HEALTH AND BIOMEDICAL SCIENCES BUILDING
MOLLY AND DOUG BARNES VISION INSTITUTE

JUSTIFICATION FOR HBSC DONOR SIGNAGE

University of Houston System University of Houston Campus Facilities Planning Committee

UNIVERSITY OF HOUSTON Campus Facilities Planning Committee Agenda Item Description Form

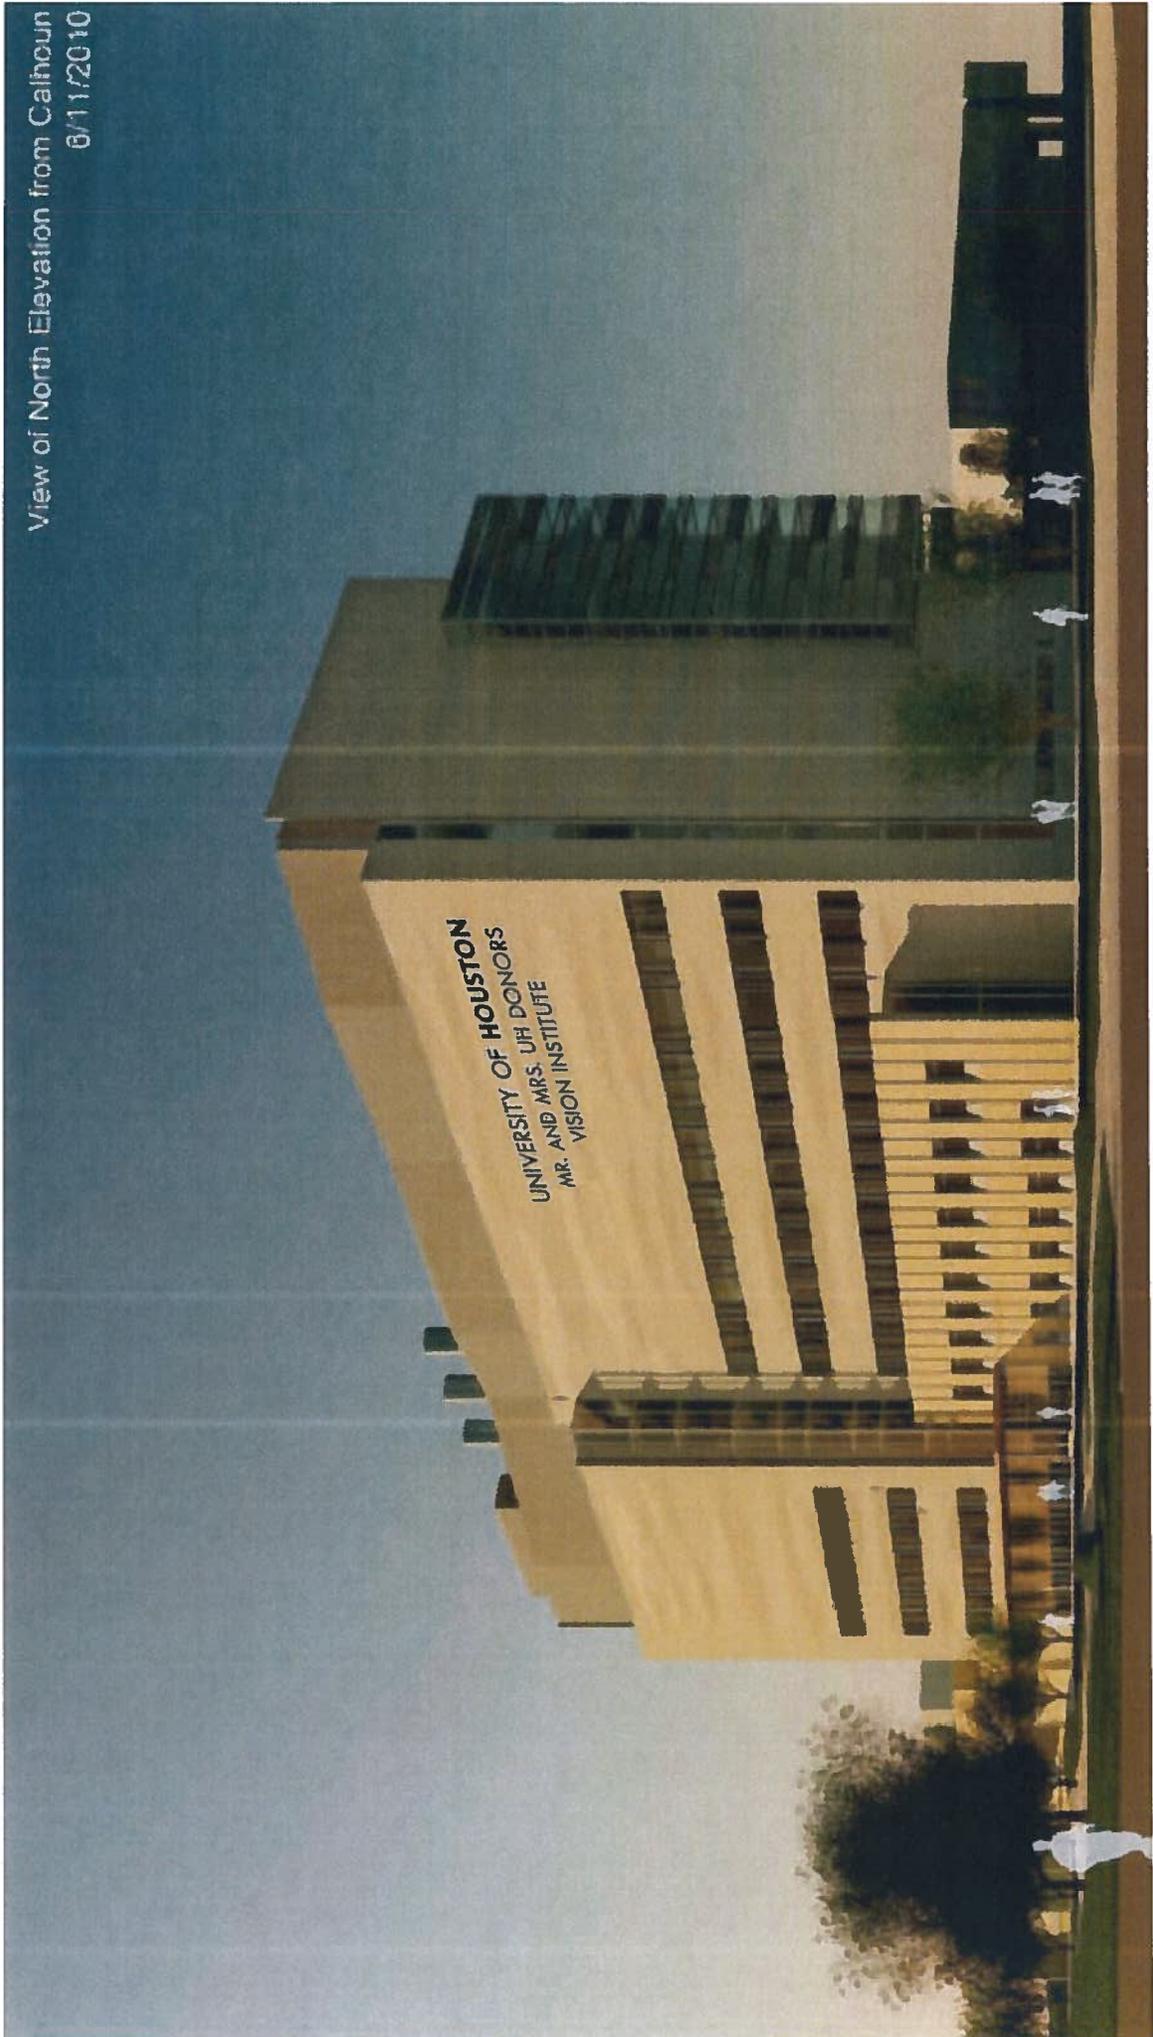
The first option is signage on the north face and displays the text in 3 lines. The logotype is approximately 60' long x 4' tall and the remaining text is approximately 32" tall. Please note that the north side precast panels on which the signs would be mounted are faceted with the result that the letters will not sit flush against the building.

Committee Recommendation: The committee recommended in concept the donor signage on the north elevation of the building. Facilities Planning and Construction will make sure that the signage is in accordance with branding standards and Facilities Management will work with Development to make sure that a maintenance budget for specialty signs like this is implemented.

1 SOUTH ELEVATION

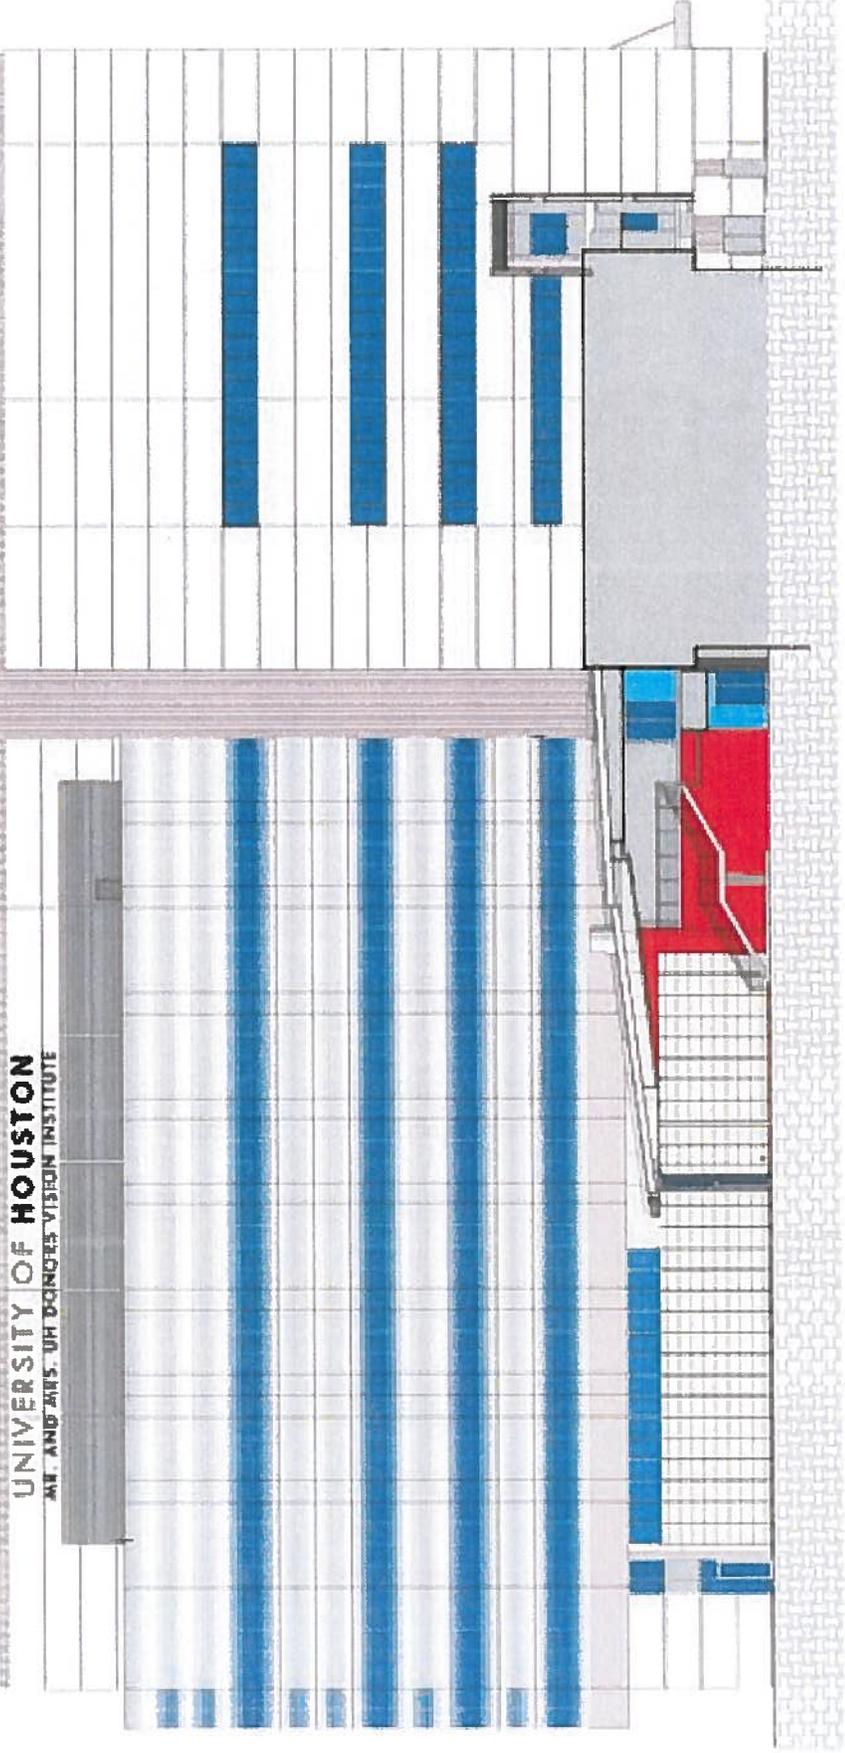
Options 2 and 3 are signage on the south face of the building. The second option shows the signage on the western end of the building, where it will be more visible from Calhoun and Wheeler. The text is in 2 lines and the logotype here is approximately 74' long and 4' high with wider spacing between the letters. Secondary text is approximately 30" tall. The third option has the signage in 2 lines located on the east side of the building and visible to

Wheeler and Spur 5. In this option the logotype length is 60" long by 4' tall with secondary text approximately 30" tall.
